RE: Lot 1 Independence Place at Cheyenne Mountain Filing No. 1A – Ponds A & B

PERMANENT BMP PLANS & DETAILS
POND B - AS-CONSTRUCTED

ELDORADO SPRINGS		DESIGNED BY: CDK	DRAWN BY: CDK
PERMANENT BMP PLANS & DETAILS		SCALE: AS SHOWN	DATE: 04/21/21
POND A - AS-CONSTRUCTED		JOB NUMBER: 91807	SHEET: GR6A OF 10

POND B
SCALE: 1" = 20'

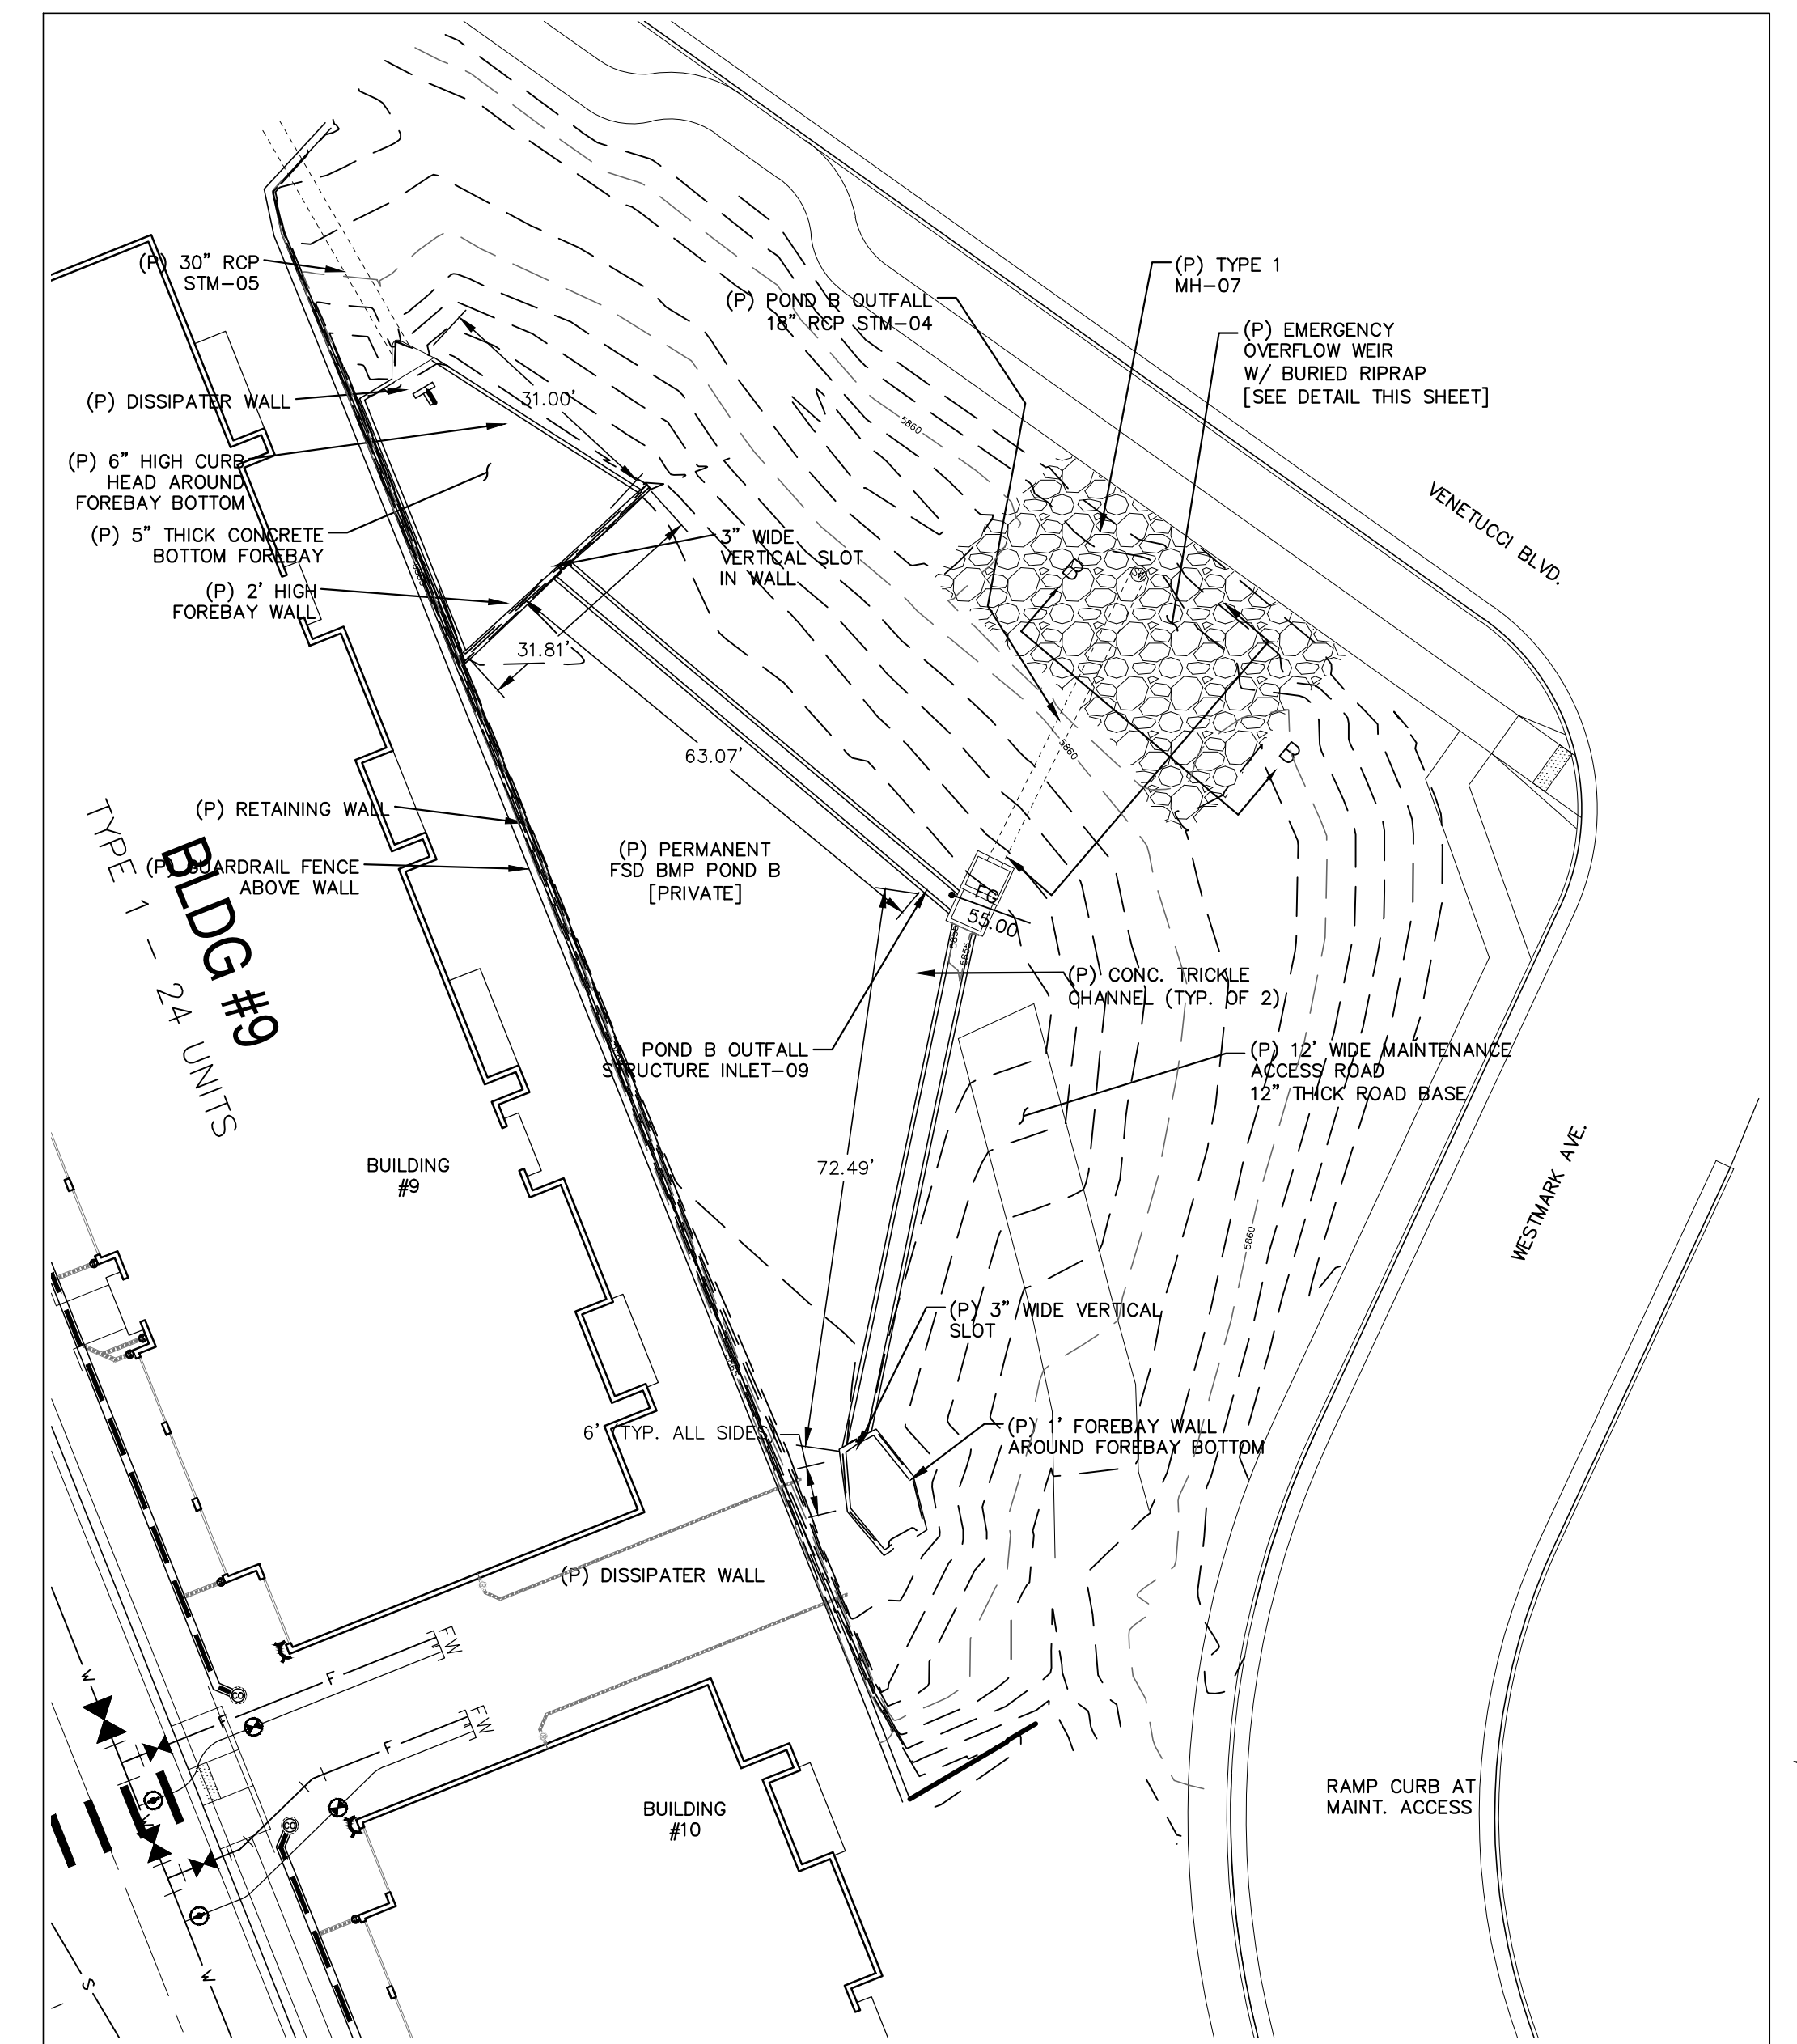
If any of the as-built changes to the pond design will effect the drain time:

Please update the MHFD-Detention Spreadsheet with the updated as-built information (pond elevations, spillway length, orifice hole elevations, etc.) to confirm that the pond is functioning as intended. The updated Spreadsheet should be attached to the Pond Certification Letter.

Include As-built condition stamp and EOR signature on each sheet. Per ECM 5.10.6 Engineering Record Drawings: Each sheet of the record drawings shall be designated as "Engineering Record Drawings" and signed and dated by the engineer of record.

Even if everything was built exactly per plan, we need an electronic PDF of the original drawings to be signed, dated, and stamped with "As-Built" on each sheet.

Differences from design to as-built conditions to be shown in red text with red clouds/bubbles.
